UNITED STATES PATENT AND TRADEMARK OFFICE

APPLICATION NO.	FILING DATE	FIRST NAMED INVENTOR	ATTORNEY DOCKET NO.	CONFIRMATION NO.
09/681,674	05/18/2001	Yoshifumi Natsuyama	JP920000096US1	3666

Office Action Summary	Application No.	Applicant(s)
	09/681,674	NATSUYAMA, YOSHIFUMI
	Examiner Timothy L Rude	Art Unit 2871

DETAILED ACTION

Figure 11

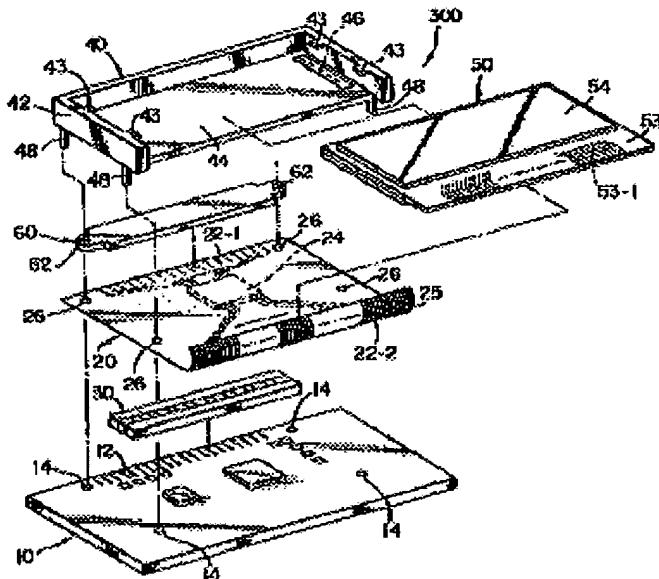
As to claim 4, Muramatsu discloses in his third embodiment, Figures 11 and 12, (col. 10 line 66 through col. 13, line 6) a liquid crystal display device, 50, comprising: a pair of glass substrates facing each other, each having electrodes for applying voltage to a liquid crystal material on a facing surface (typical); a circuit board, 10, for supplying said voltage; and a liquid crystal driver tape carrier package, 20, (col. 11, lines 7-9 and col. 7, lines 1-3) for connecting said electrodes of said glass substrates to said circuit board and mounting a liquid crystal driver chip (col. 11, lines 7-9 and col. 7, lines 4-13), wherein said liquid crystal driver tape carrier package and said circuit board anchor holes, 26 and 14, and anchor pins, 48, are inserted into said anchor holes, whereby said liquid crystal tape carrier package is fixed to said circuit board (col. 11, lines 45-48).

Muramatsu does not explicitly disclose a display wherein said liquid crystal driver tape carrier package is soldered to said circuit board via said pins.

As to claim 5, Muramatsu discloses the liquid crystal display device further comprising a light guide, 44 (Applicant's frame), for allowing said anchor pins to stand on a surface holding said pair of glass substrates, wherein said liquid crystal driver tape carrier package and said circuit board are fixed to said frame.

As to claim 6, Muramatsu discloses the liquid crystal display device wherein a pair of said anchor holes, 26, is located with said liquid crystal driver chip, 24, between (diagonally per Figure 11).
